Permit Application Review Report
Date: 9/9/2026

Project Name: Mn Meadows Wetland Bank

Project PAN: P-26-046

Project Purpose: construction of a wetland bank

Figure 3: Floodplain Impact/Mitigation

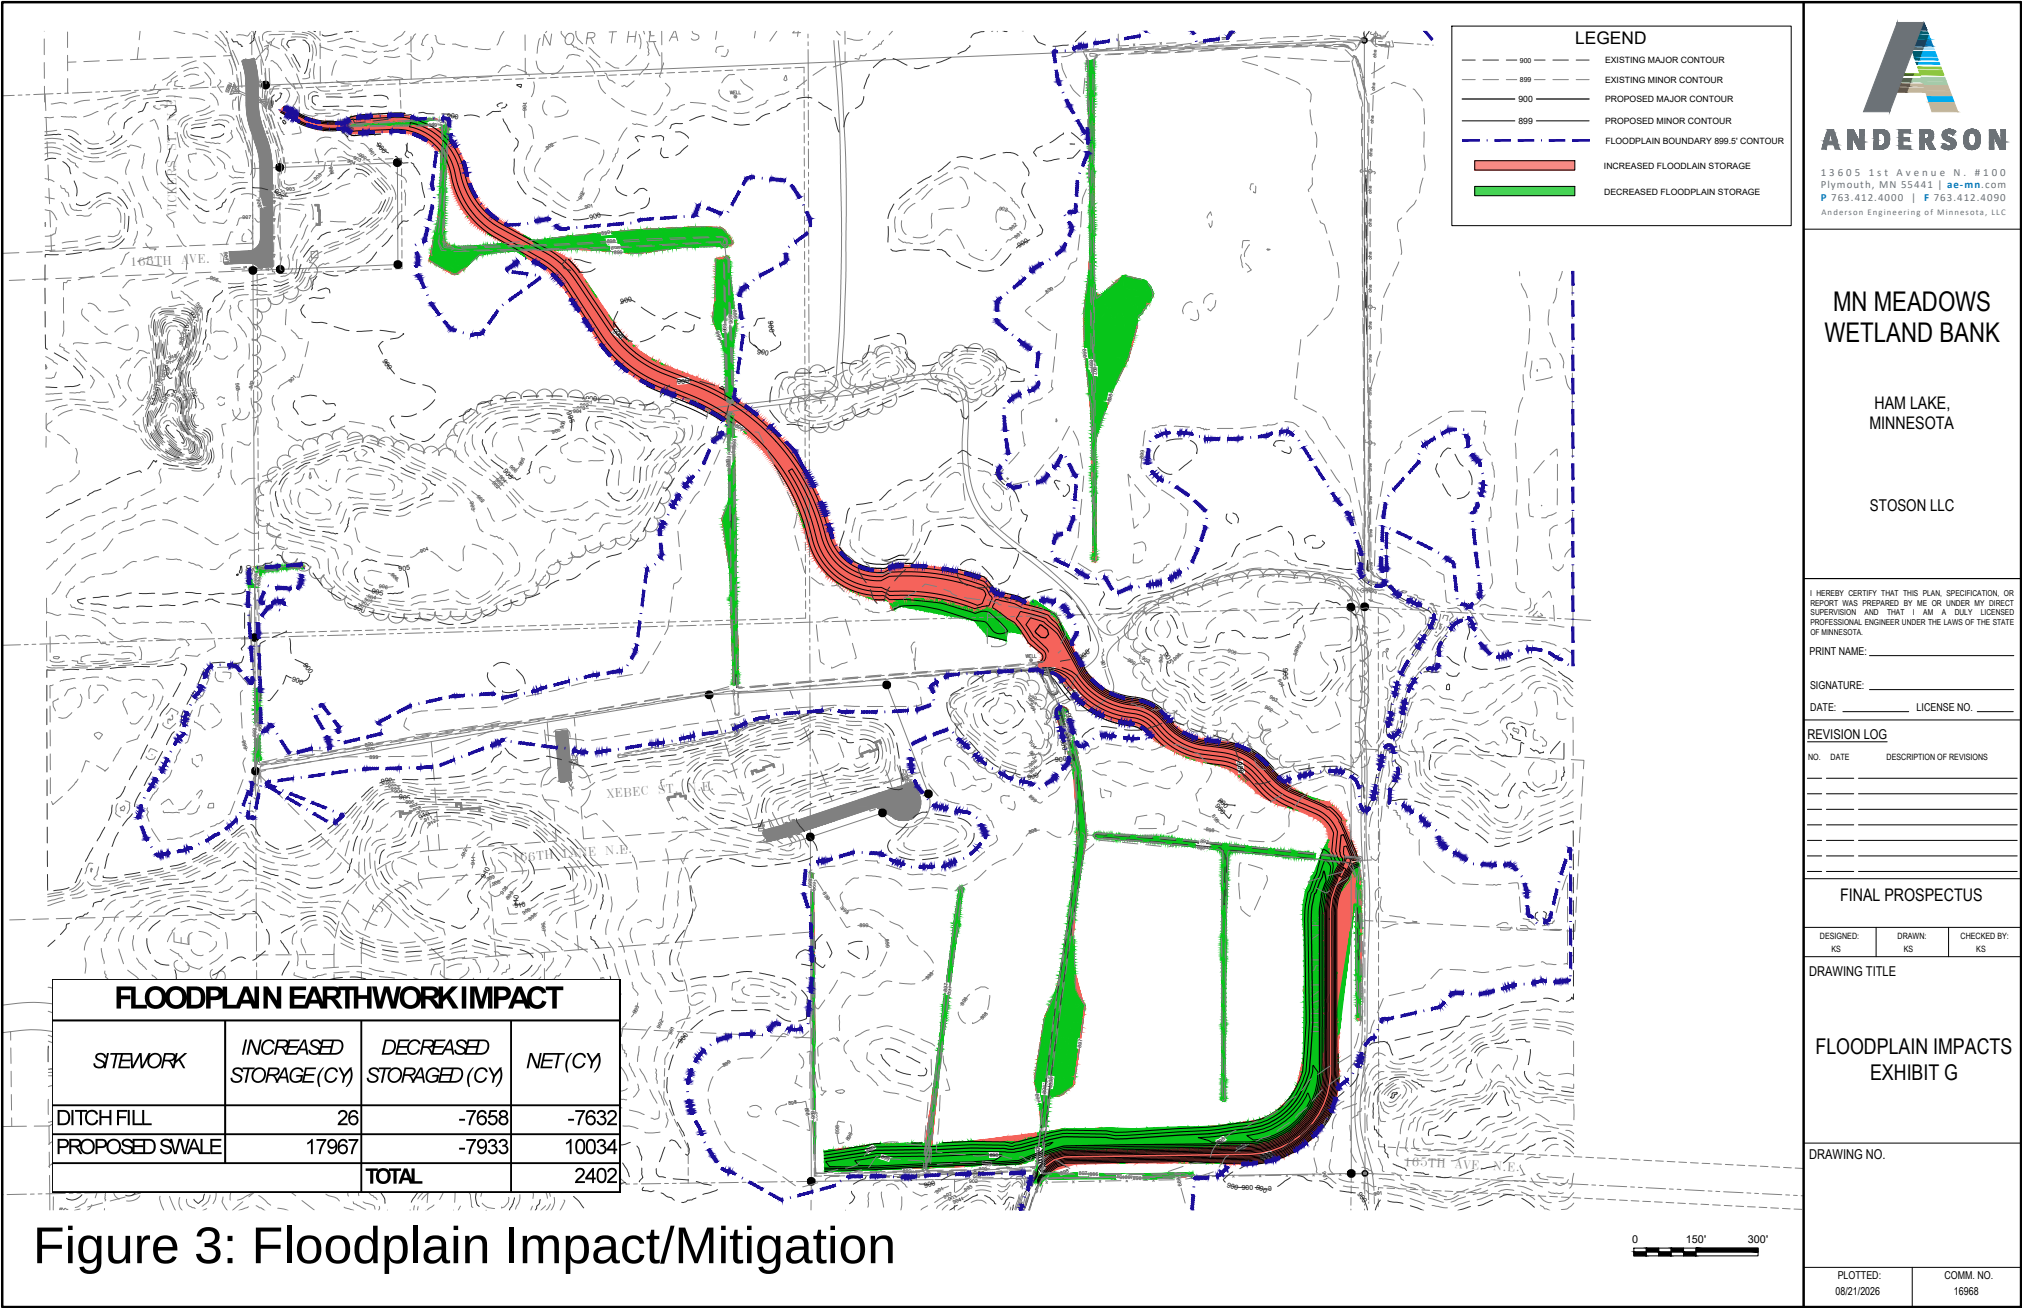
The regulatory floodplain elevation is 899.5 NAVD 88. The application proposes the placement of 7,632 cubic yards of fill within the floodplain. Compensatory storage is required. The proposed project provides 10,032 cubic yards of compensatory storage, which exceeds the required 1:1 ratio and is within the relevant reach.

The proposed fill within the floodplain is an embankment. The proposed project affects the conveyance capacity of channel, however, the discharge rate from the site (to CD 11) is maintained in 2, 10, and 100-yr storm events. See Figure 3: Floodplain Impact.
